## A1: Use of either/and, plural of TLP

Errata for ATS Specification 1.0

**Figure 4-1: ATS Extended Capability Header**

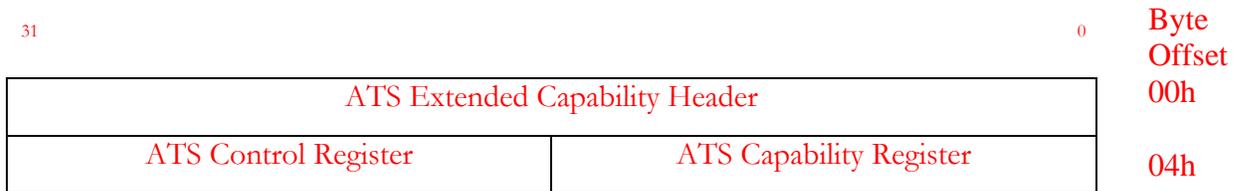
**A11: ATS capability should be in extended configuration space**

Page 35, section 4.1 “ATS Capability Structure”

*Note: This section has been rewritten in entirety.*

Each Function that supports ATS must have the ATS Extended Capability structure in its extended configuration space.

Figure 4-1 details allocation of the register fields in the ATS Capability structure.
